1
B0300032

## SB, 240 R, 245 R, 245 RX, Clutch, 2003-05

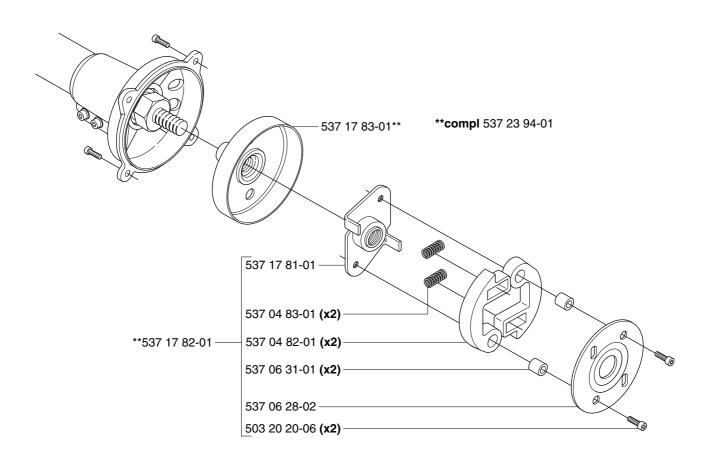
A new clutch has been developed as an alternative for the 240 and 245 models. It is based on the same components that are used in the clutch for the 250R, apart from the clutch hub.

When the standard clutch is replaced with this clutch, the clutch drum must be replaced at the same time, and the clutch and clutch drum will therefore be supplied as a set.

Note also that the clutch must always be fitted with the large washer facing the engine. See diagram.
